Service Bulletin

Category 7	Applicable Model/s 1988-89 MX-6/626 1988-89 323 Turbo	Subject MTX PRIMARY SHAFT	Bulletin No. 050/88 Issued 11/4/88 Revised
---------------	---	------------------------------	--

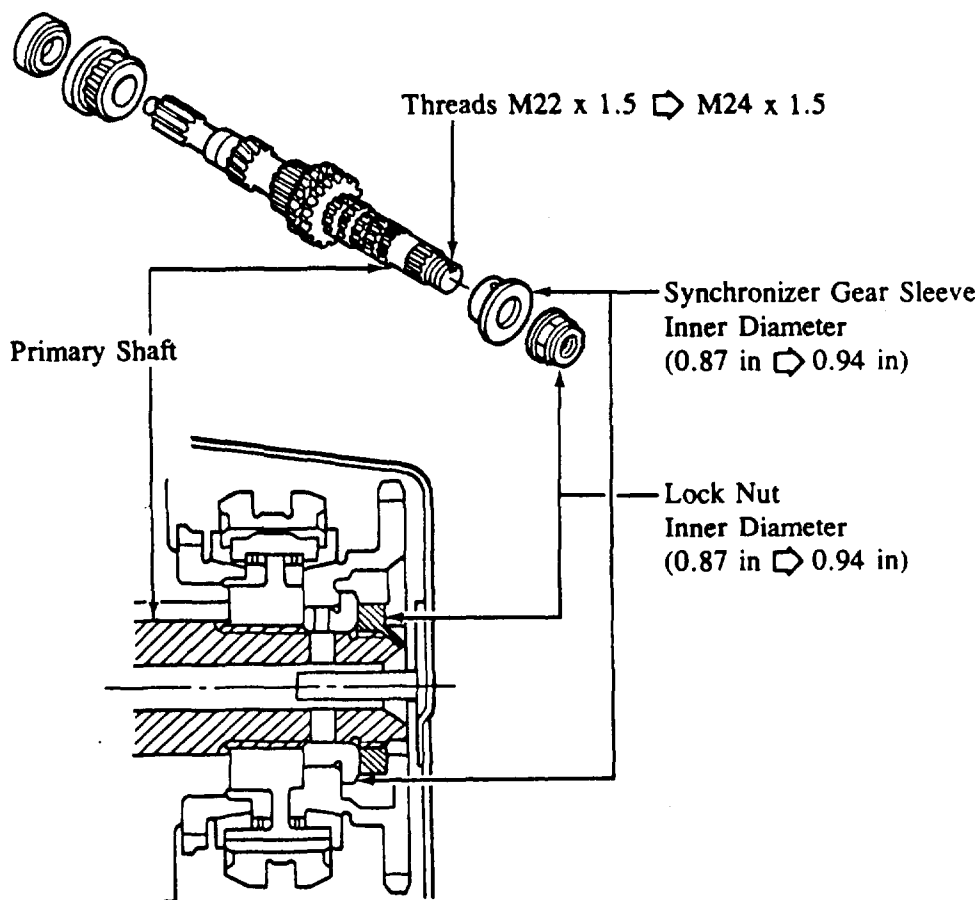
A diameter of the primary shaft end portion has been increased to 0.94 in (24 mm) from 0.87 in (22 mm) as shown below in order to increase the strength of the threaded portion of the primary shaft.

Due to the modification, the synchronizer gear sleeve and lock nut shown in the illustration have also been modified accordingly. Therefore, the modified primary shaft must be installed together with the modified synchronizer gear sleeve and lock nut.
